VCBO® ADDENDUM 001

project	Intermountain Healthcare PKH CT Remodel	project no	22545
date	2024-01-11	no. pages	
owner	Intermountain Healthcare		
contractor			
bid date	2024-01-19	bid time	4:00 pm

A3 CT PROCEDURE - ANNOTATED & DIMENSION PLAN
SCALE: 1/4" = 1'-0"

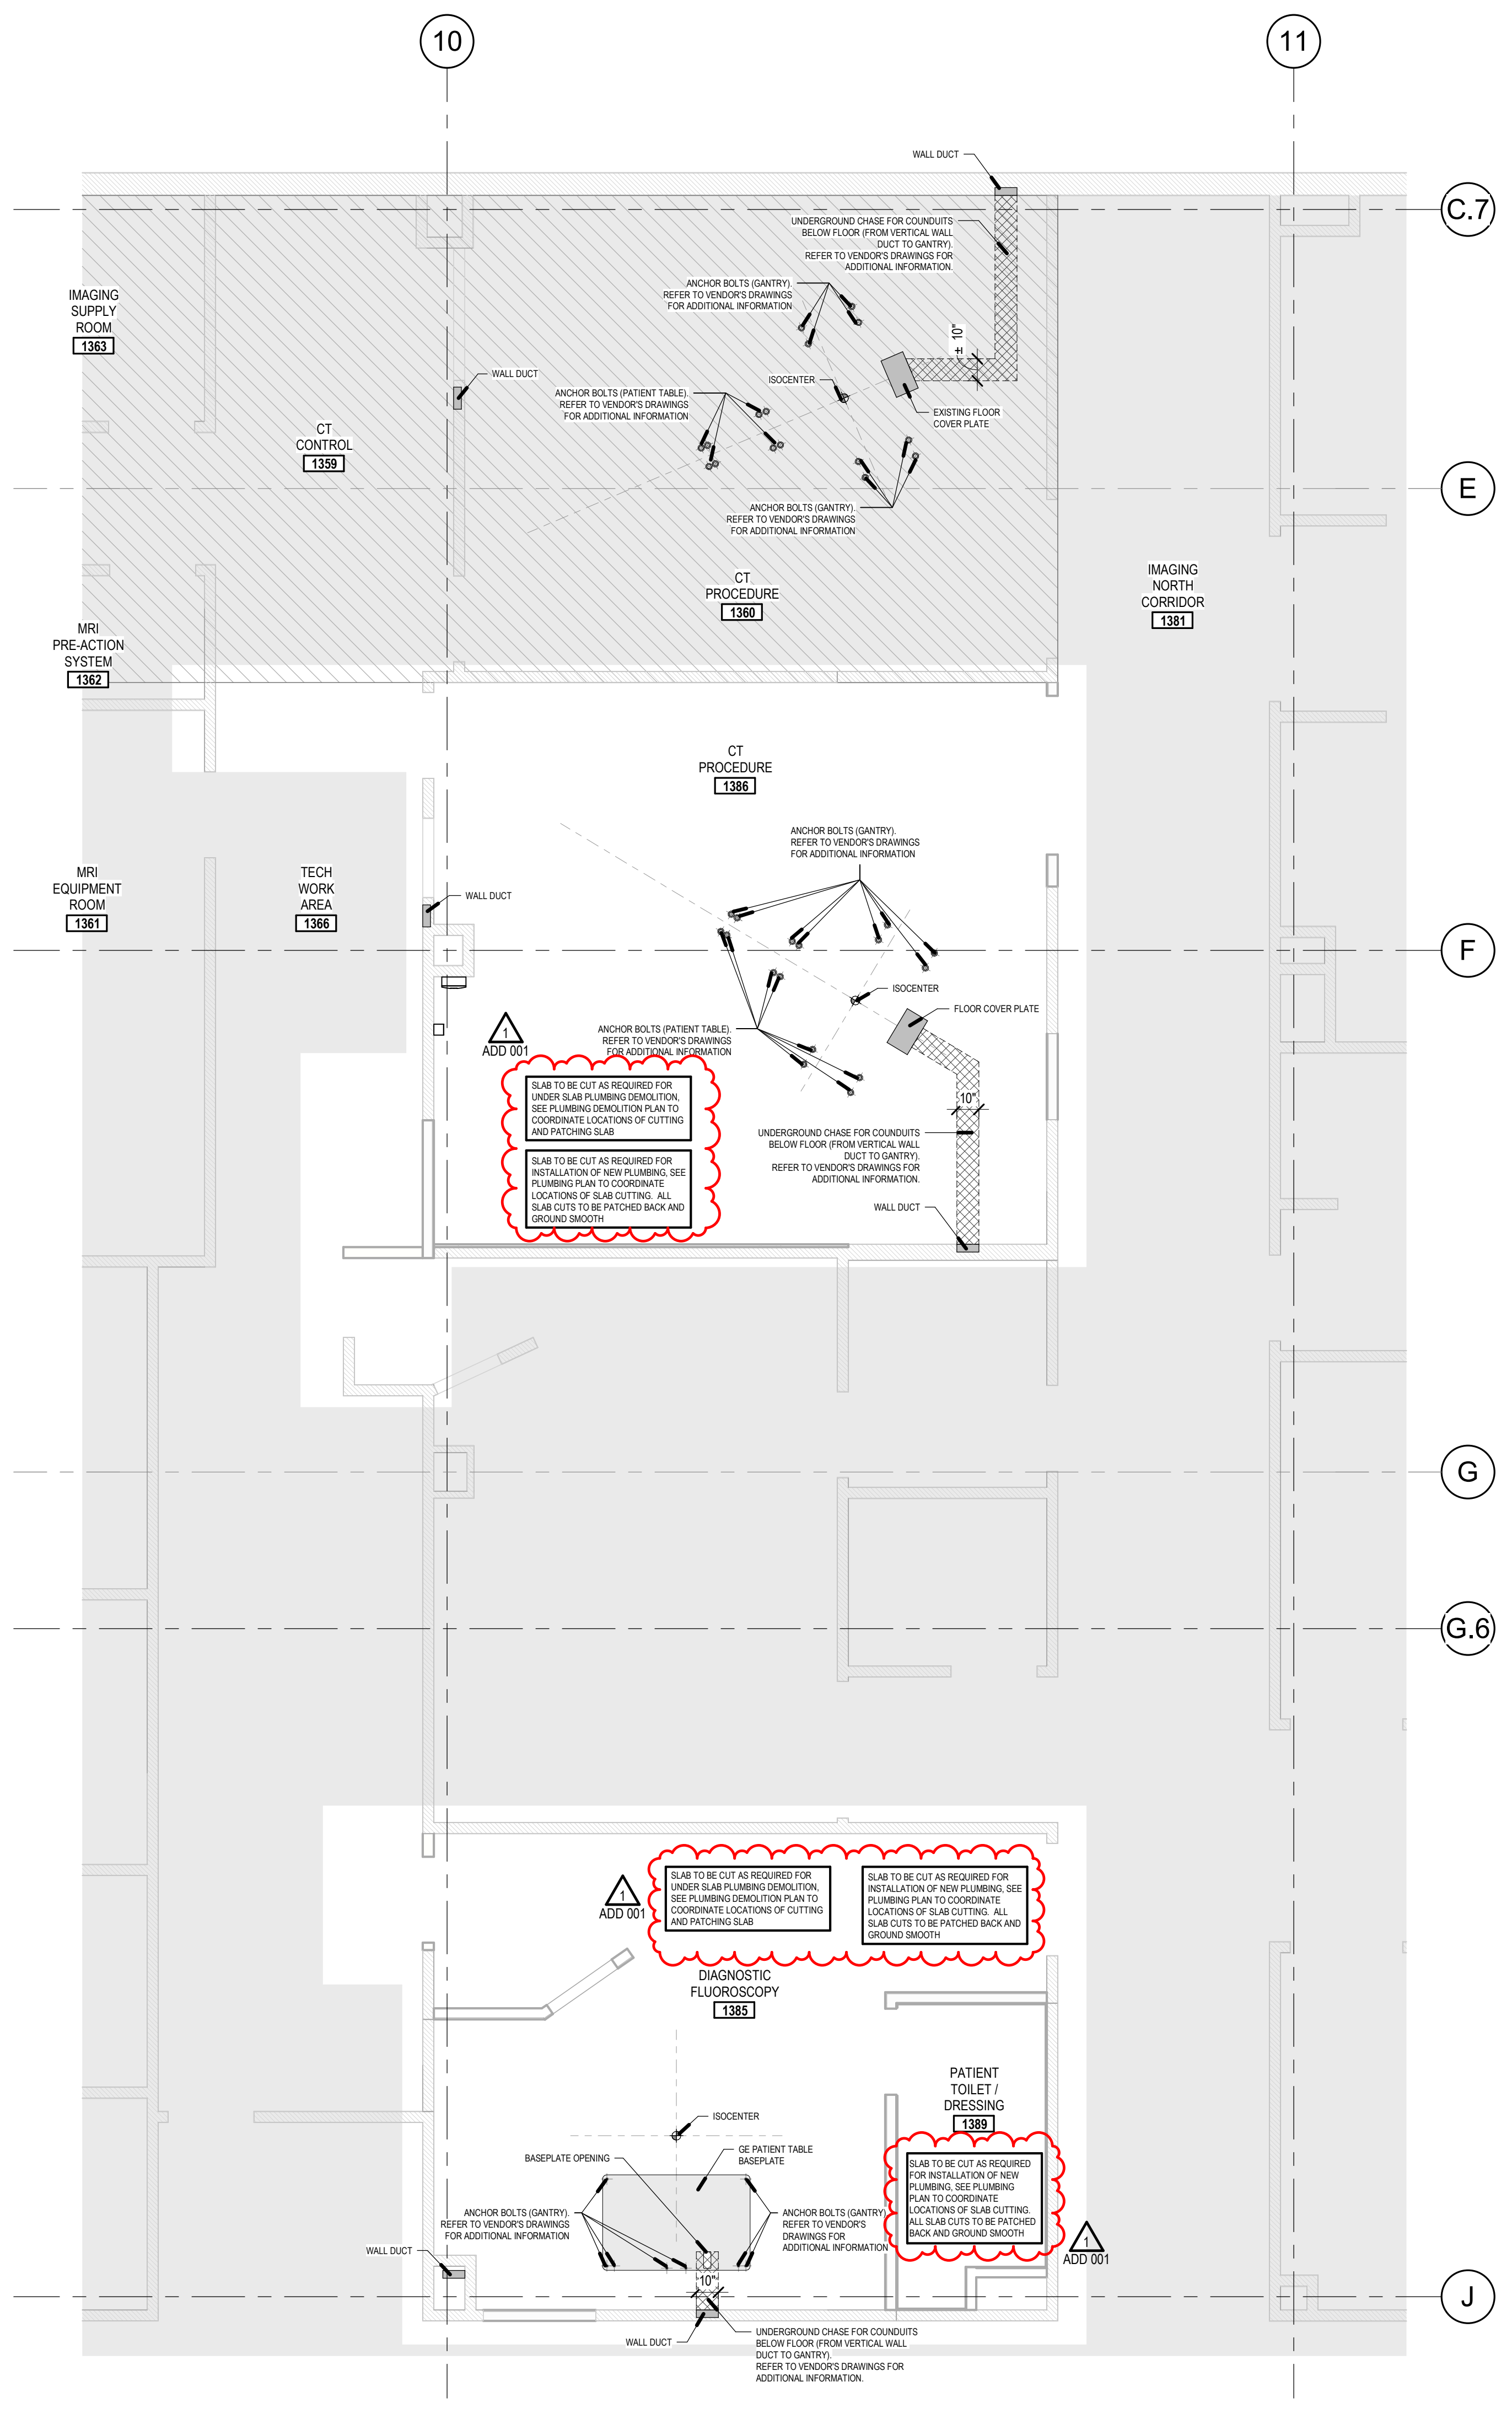
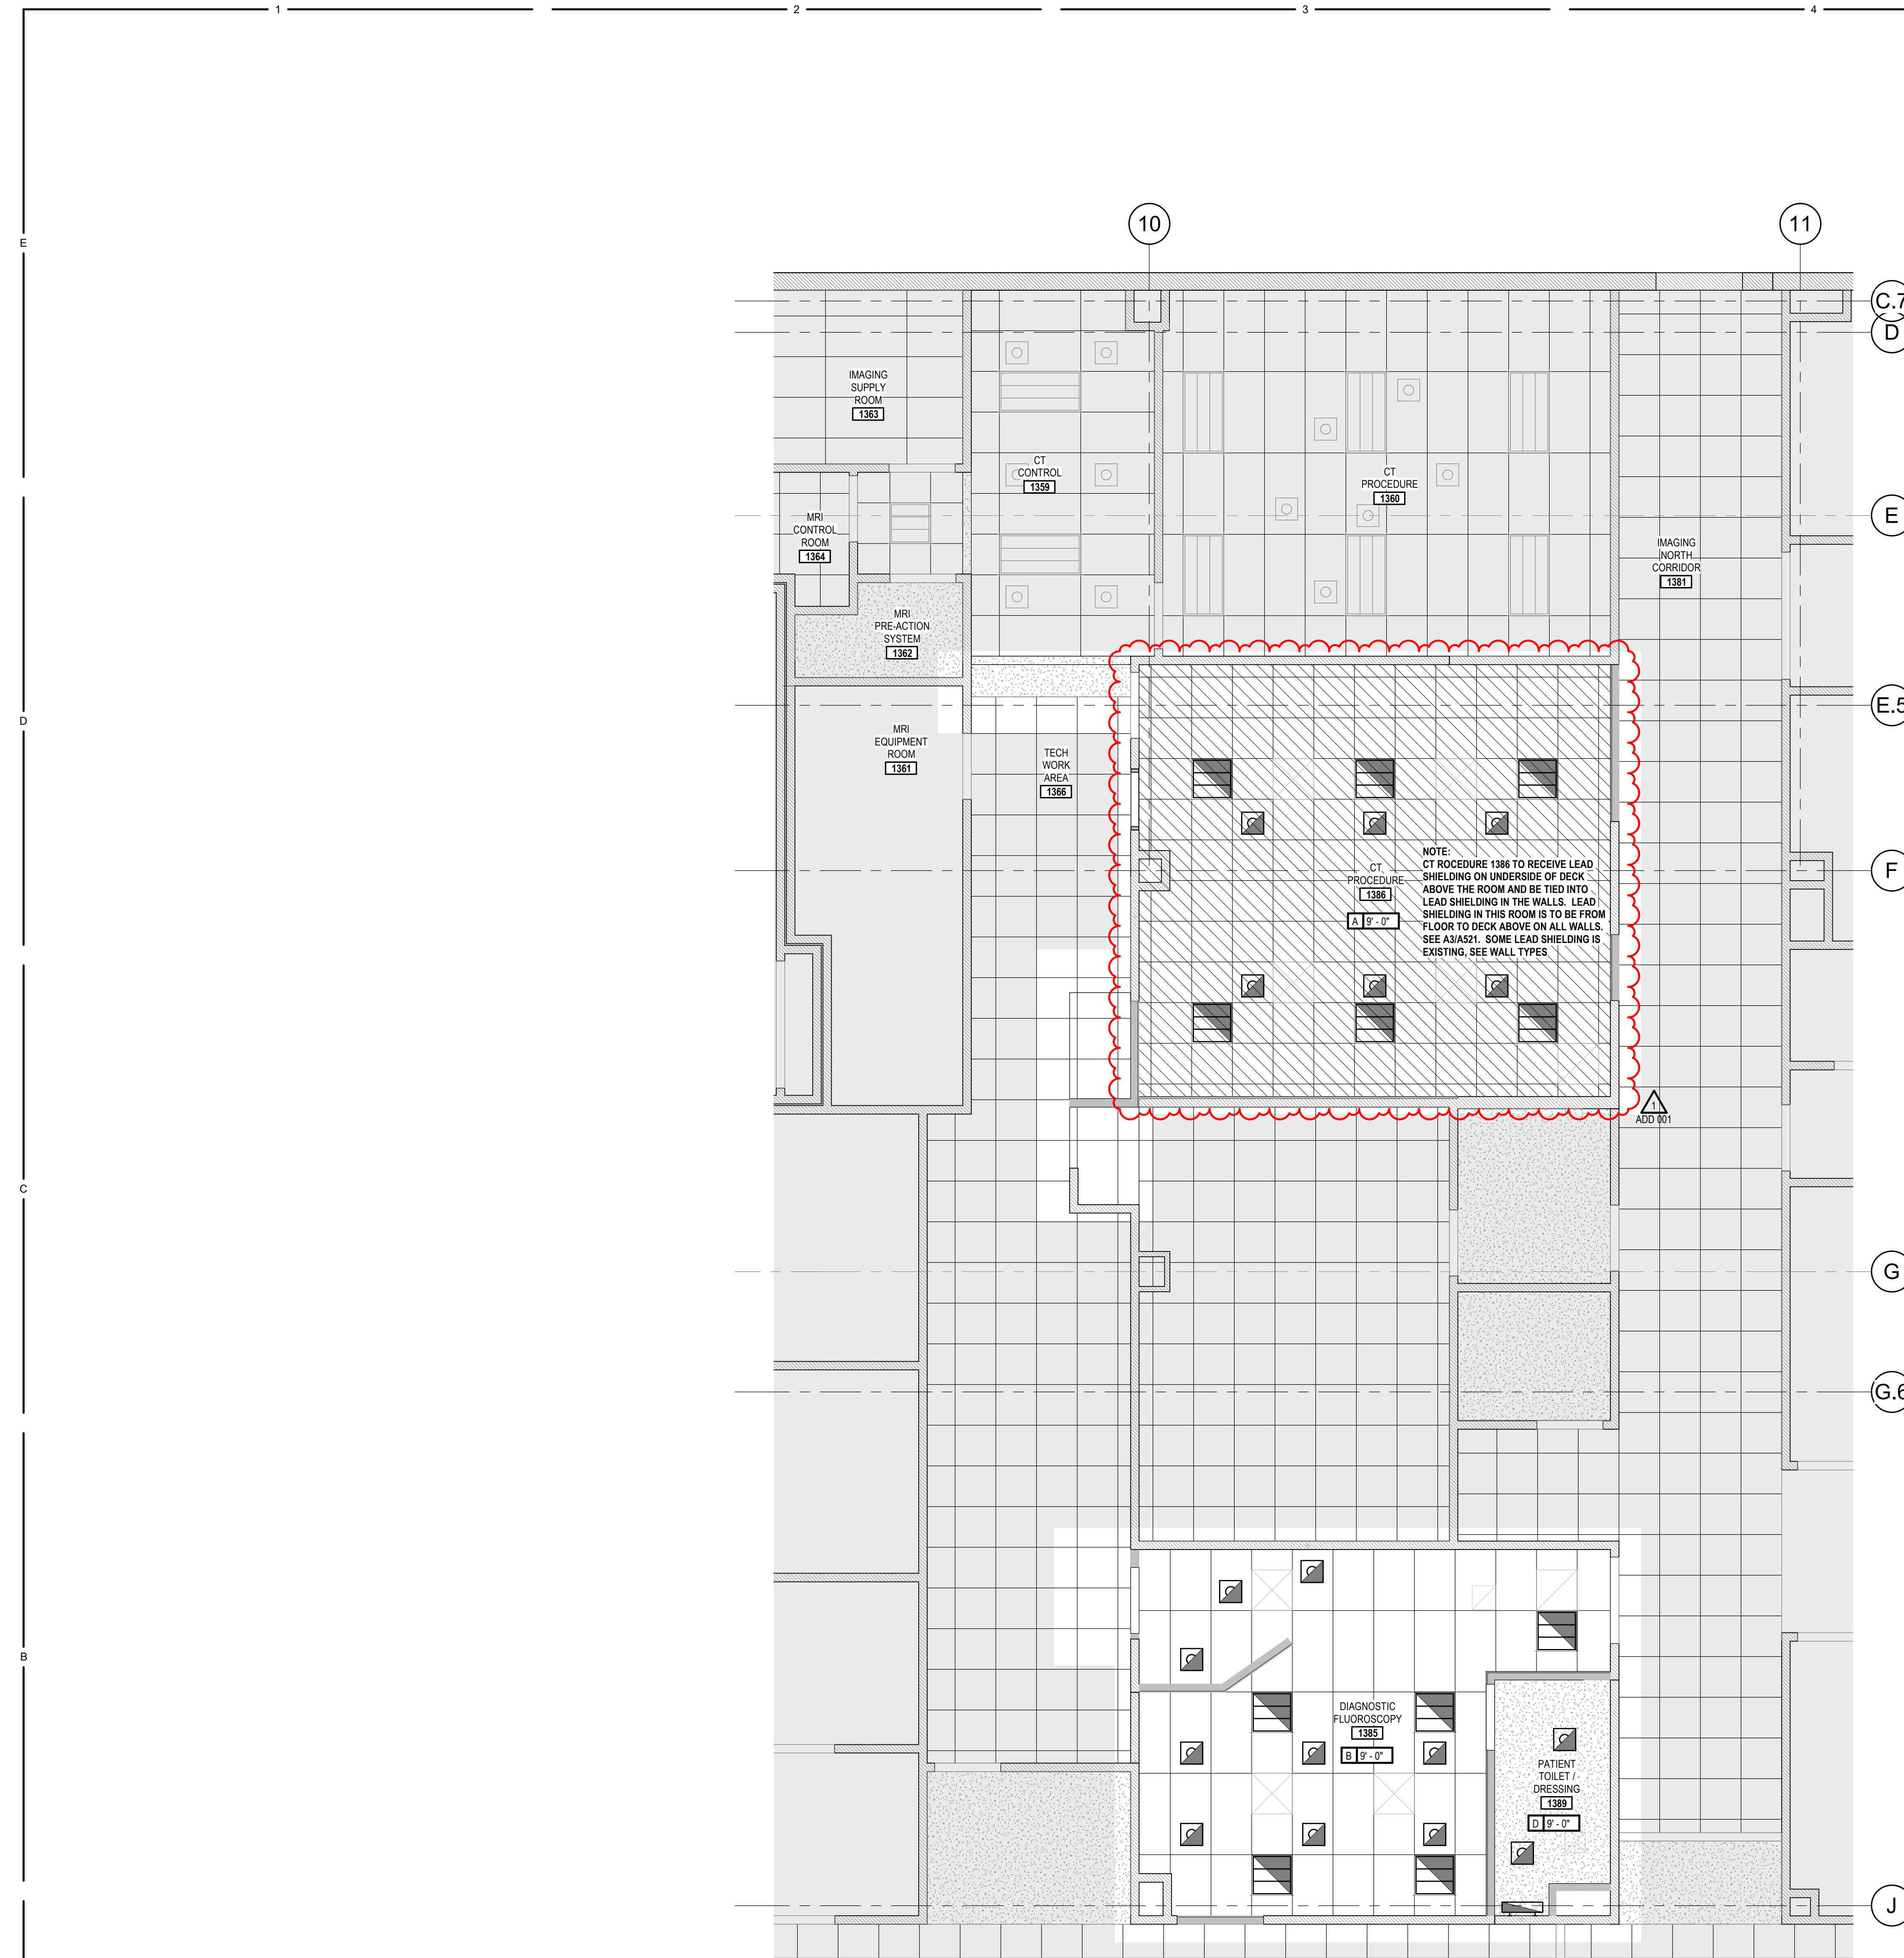
1.2	AS101	OVERALL SITE PLAN <ol style="list-style-type: none">1. REVISED LOCATION OF PROJECT WITHIN THE EXISTING BUILDING AS CLOUDED.
1.3	A110	FIRST FLOOR - SLAB PLAN, ANNOTATED & DIMENSION PLAN <ol style="list-style-type: none">1. ADD NOTES FOR SLAB CUTTING AS CLOUDED.2. REVISED WALL TYPES AS CLOUDED.3. ADD EXISTING COUNTERTOP AND MILLWORK TO BE RELOCATED IN TECH

WORK AREA 1366. THIS MILLWORK IS EXISTING IN THIS ROOM AND IS TO RELOCATED TO THE LOCATION SHOWN ON THIS DRAWING.
